Exhibit G

PROJECT  
412 Richardson PL  
412 Richardson Place, NW  
Washington, DC

DRAWING TITLE  
CELLAR AND FIRST  
LEVEL PLAN -  
PROPOSED

A101  
Board of Zoning Adjustment  
District of Columbia  
CASE NO. 19441  
ENR 101-10-2016

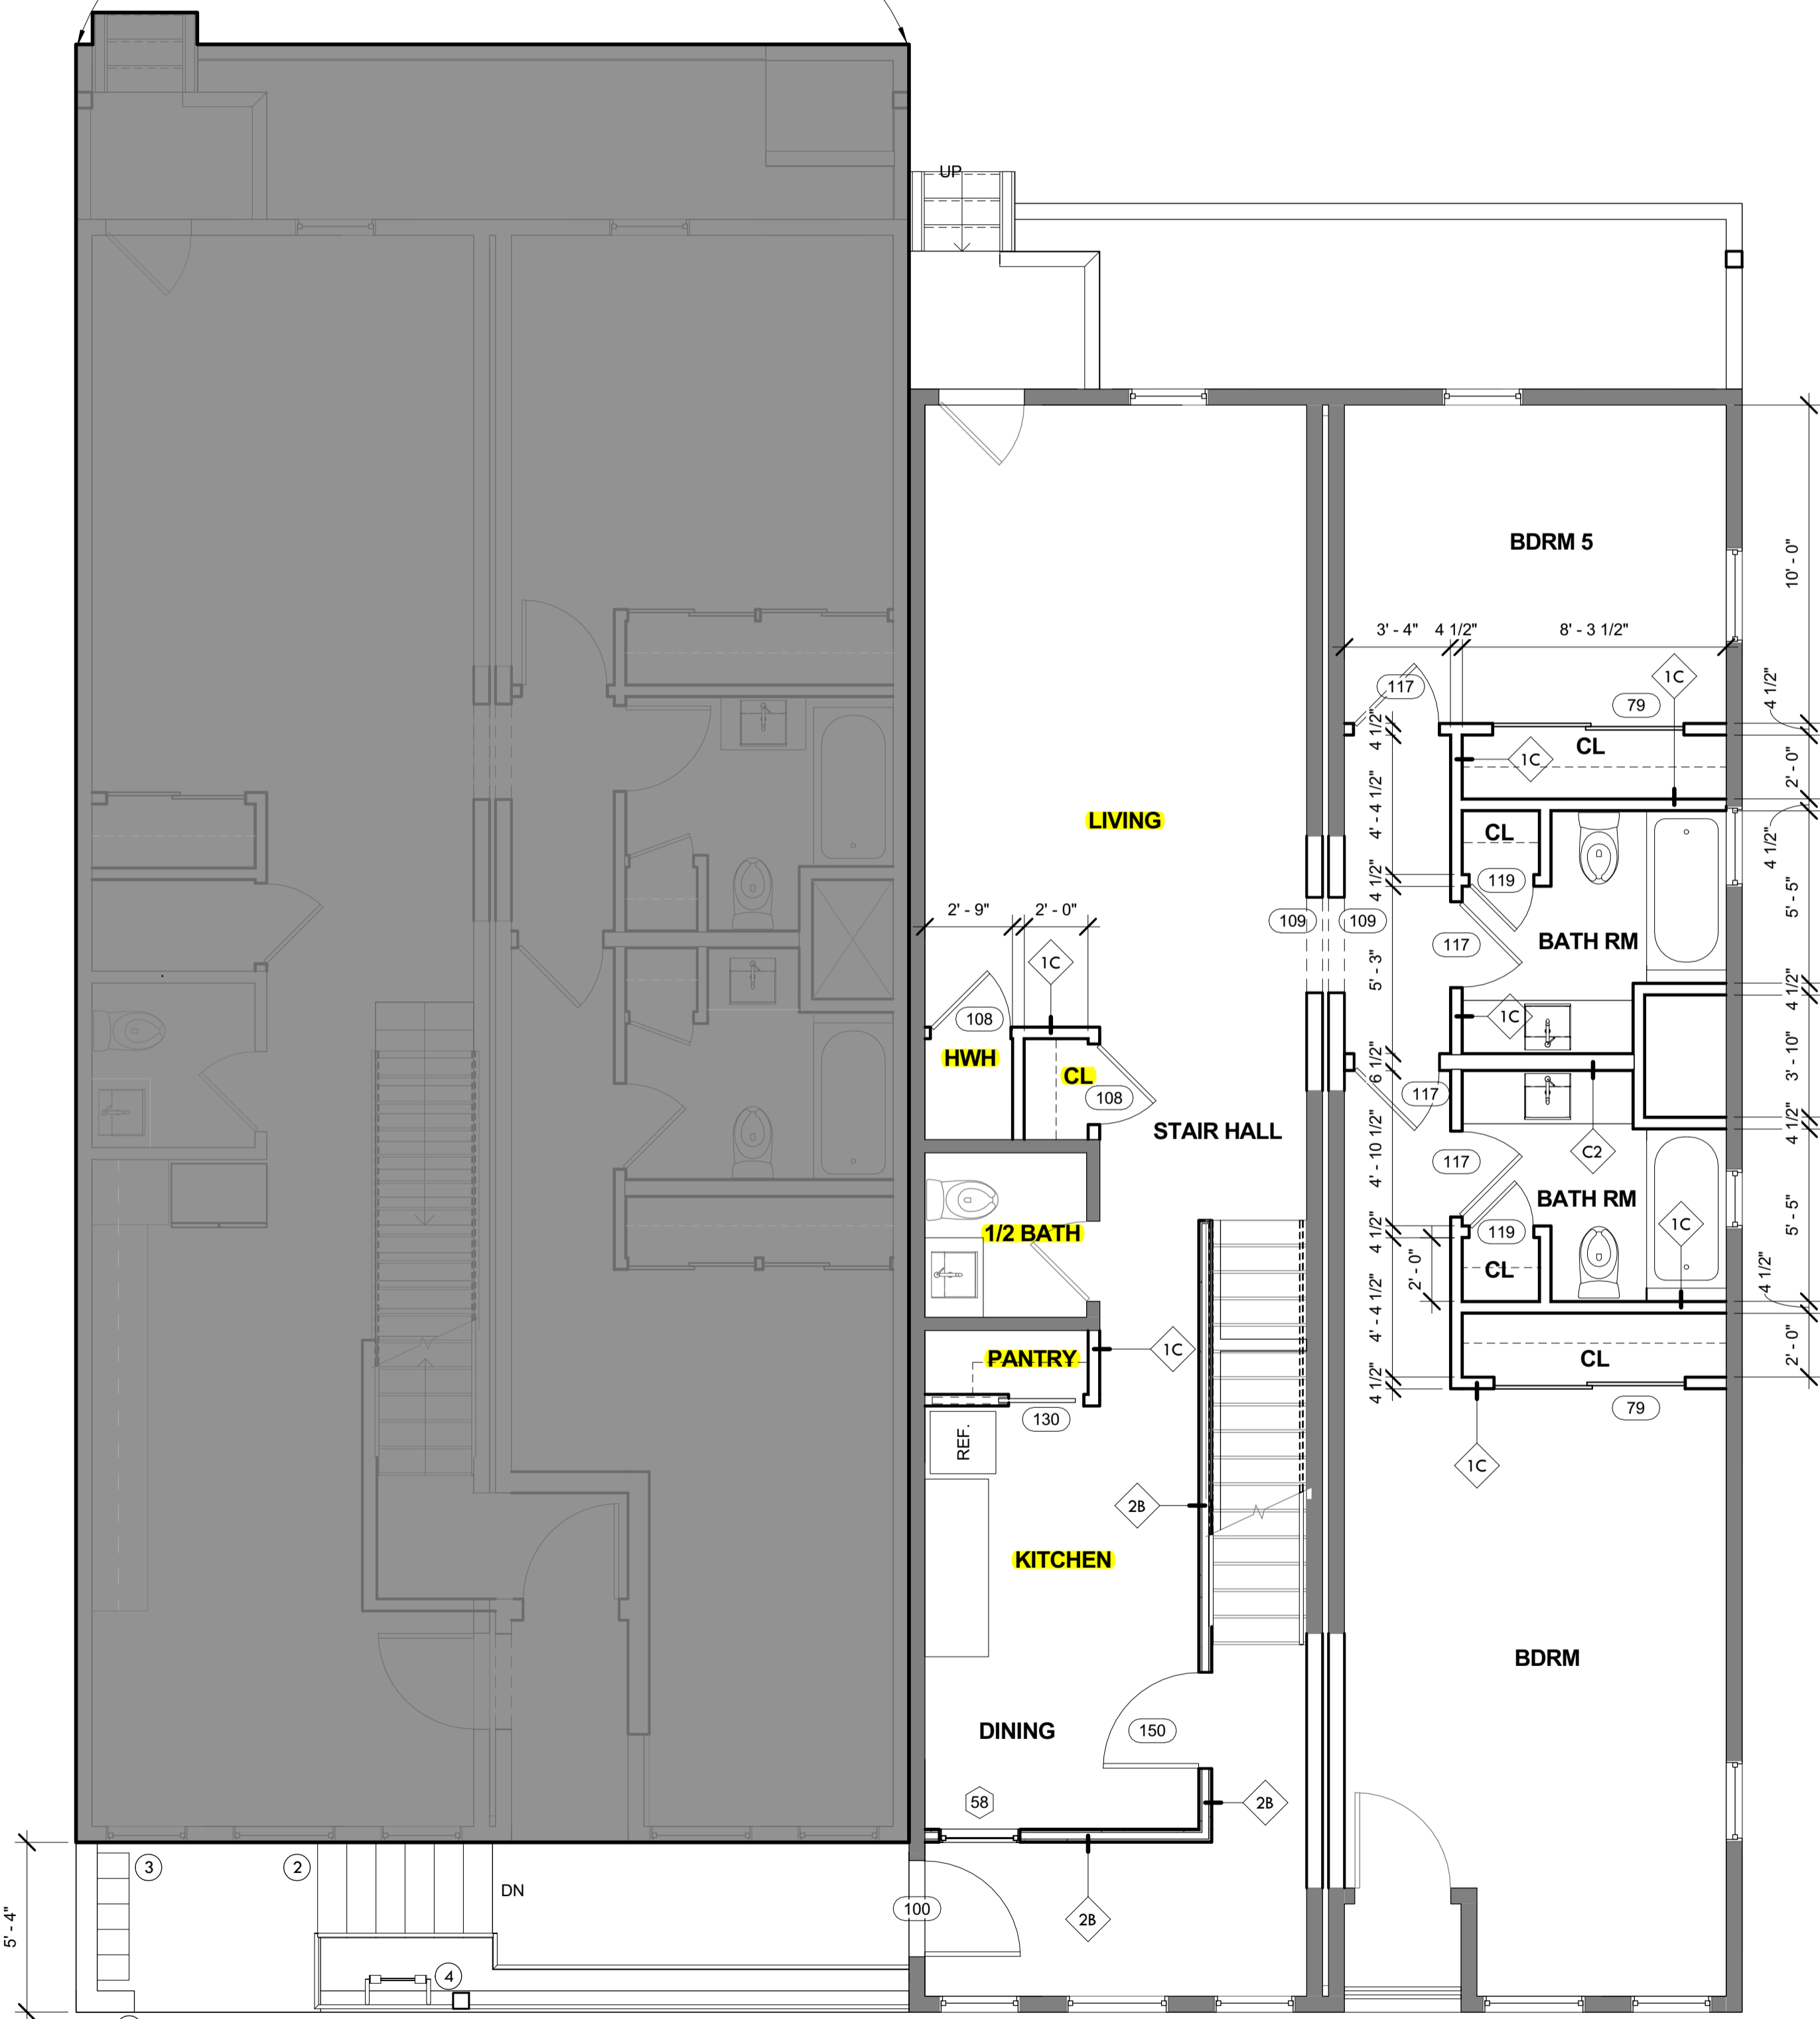
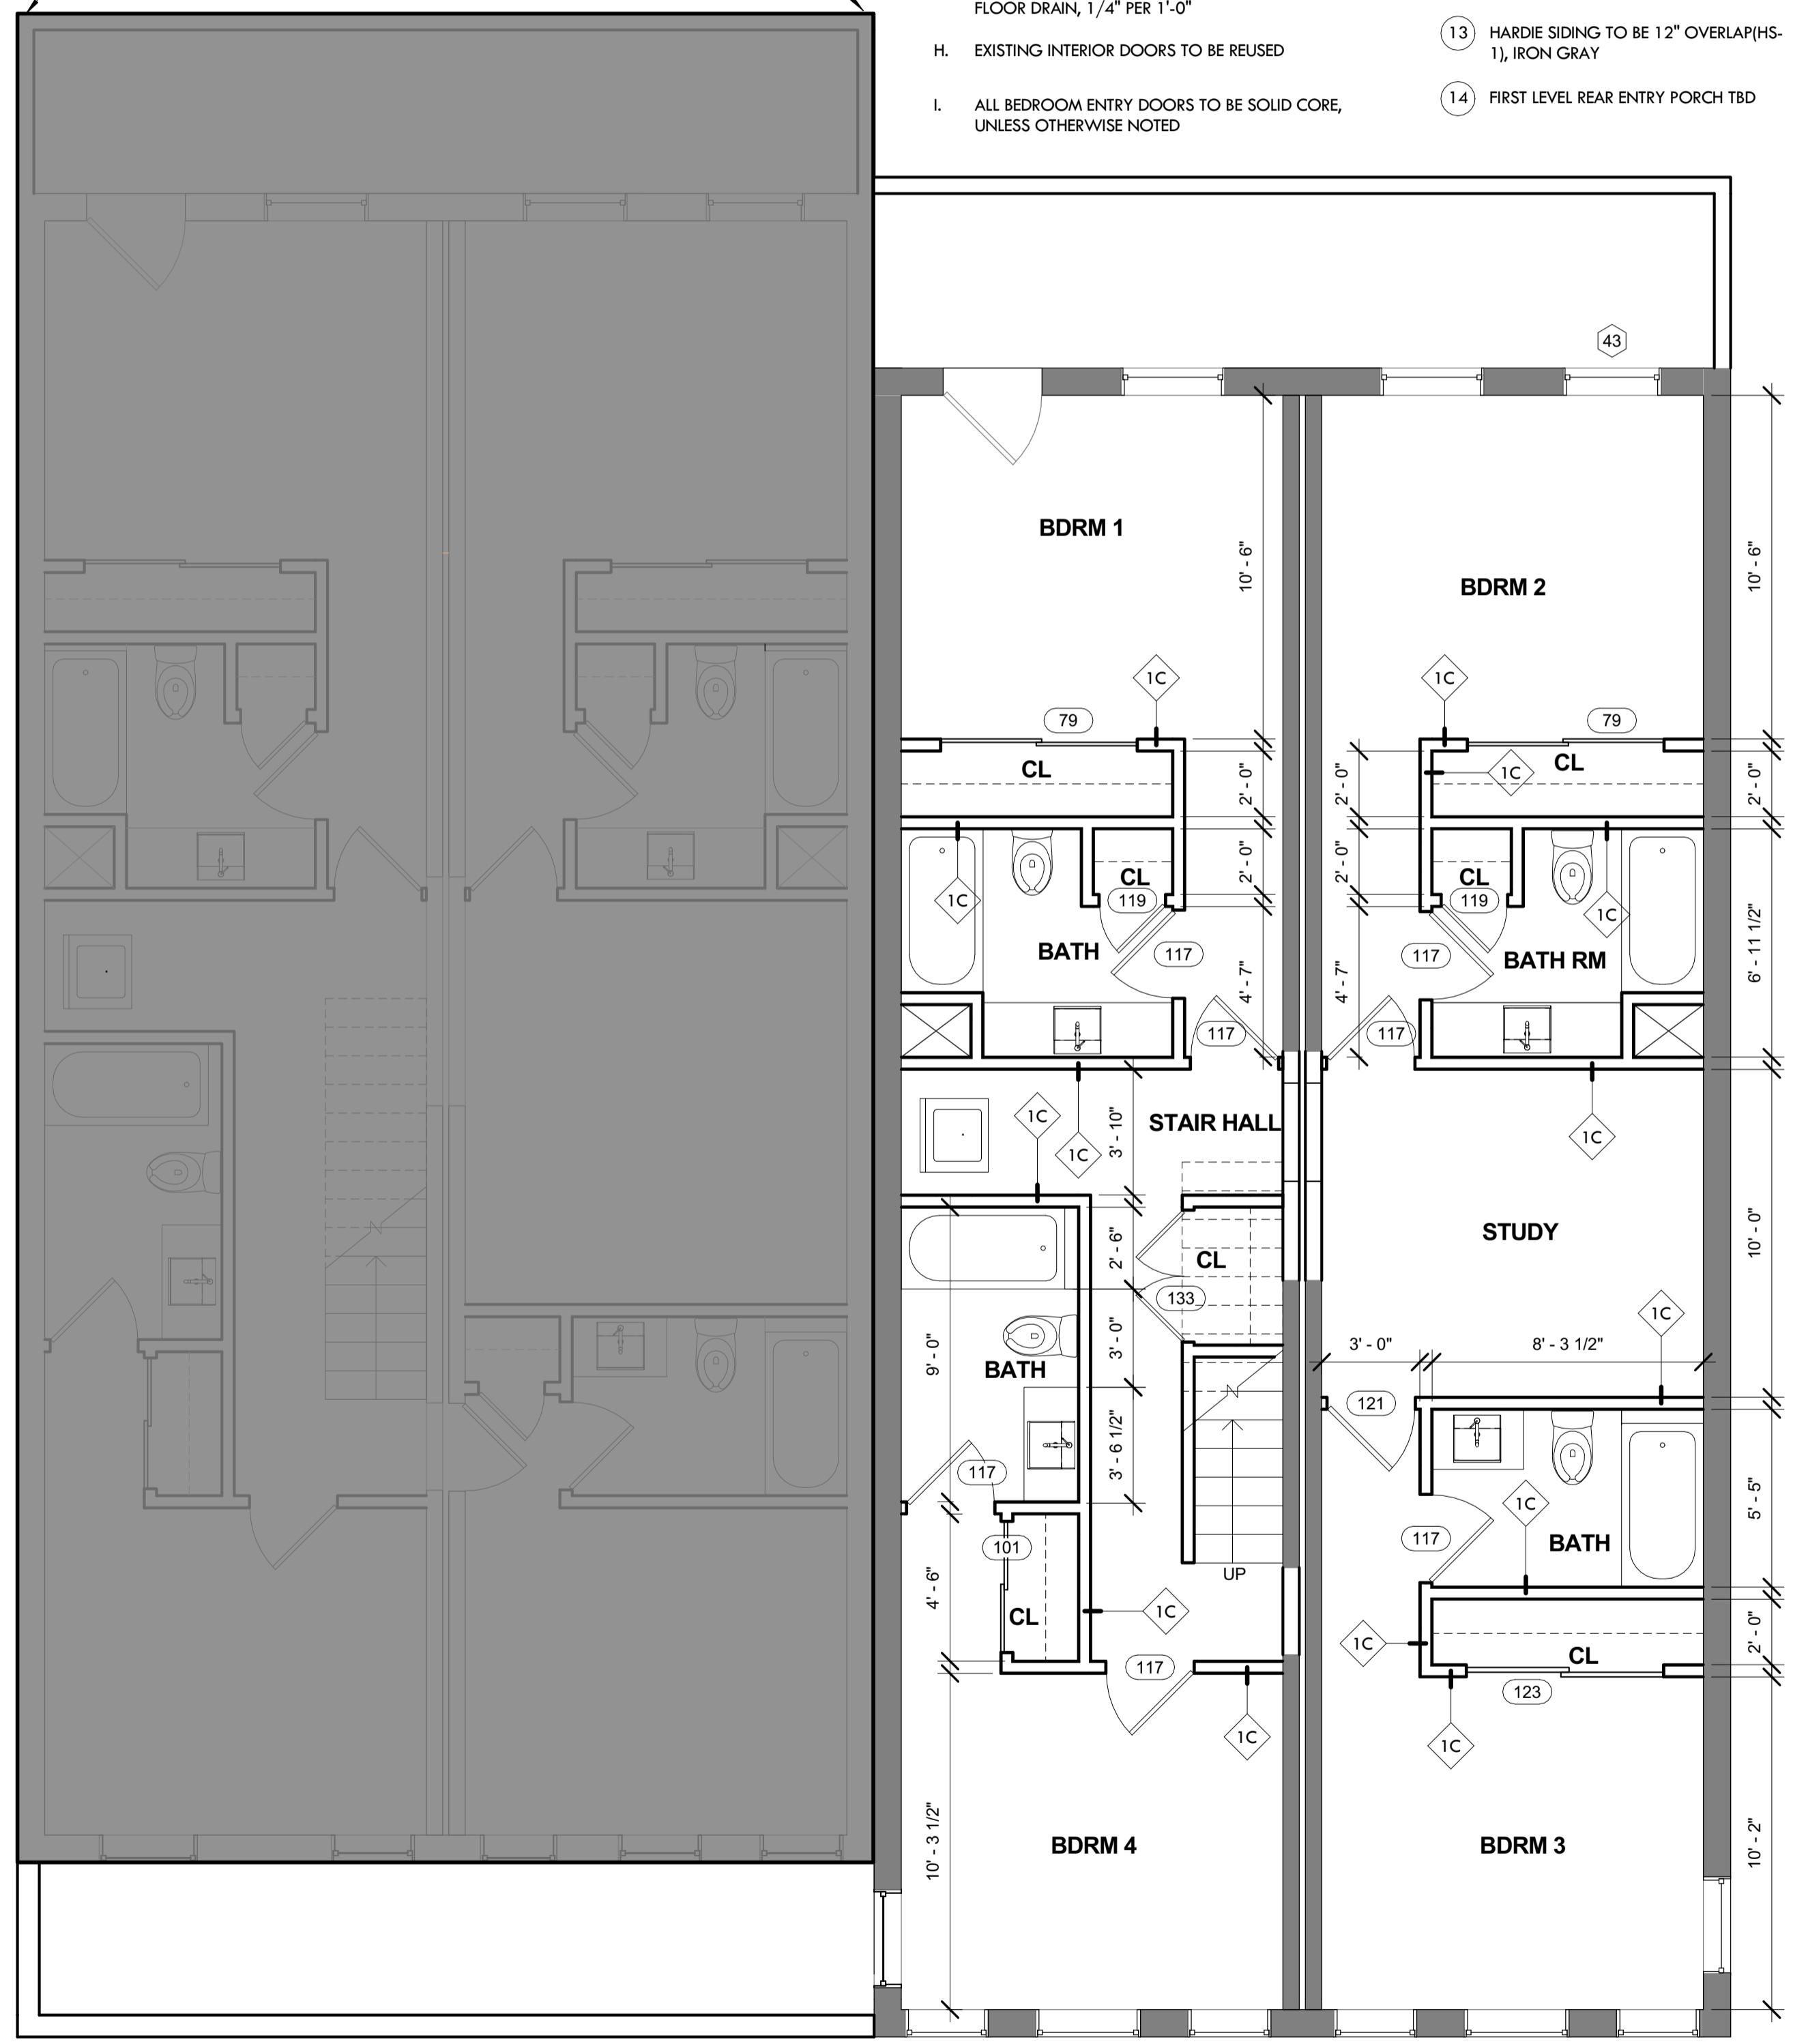
906.2 General requirements. Portable fire Extinguishers shall be selected, installed and maintained in accordance with this section and NFPA 10.

906.3.1 Class A fire hazards. Portable fire extinguishers for occupancies that involve primarily Class A fire hazards, the minimum sizes and distribution shall comply with Table 906.3(1).

906.9.1 Extinguishers weighing 40 pounds or less. Portable fire extinguishers having a gross weight not exceeding 40 pounds (18 kg) shall be installed so that their tops are not more than 5 feet (1524 mm) above the floor.

906.2 General requirements. Portable fire Extinguishers shall be selected, installed and maintained in accordance with this section and NFPA 10.

906.3.1 Class A fire hazards. Portable fire extinguishers for occupancies that involve primarily Class A fire hazards, the minimum sizes and distribution shall comply with Table 906.3(1).

906.9.1 Extinguishers weighing 40 pounds or less. Portable fire extinguishers having a gross weight not exceeding 40 pounds (18 kg) shall be installed so that their tops are not more than 5 feet (1524 mm) above the floor.
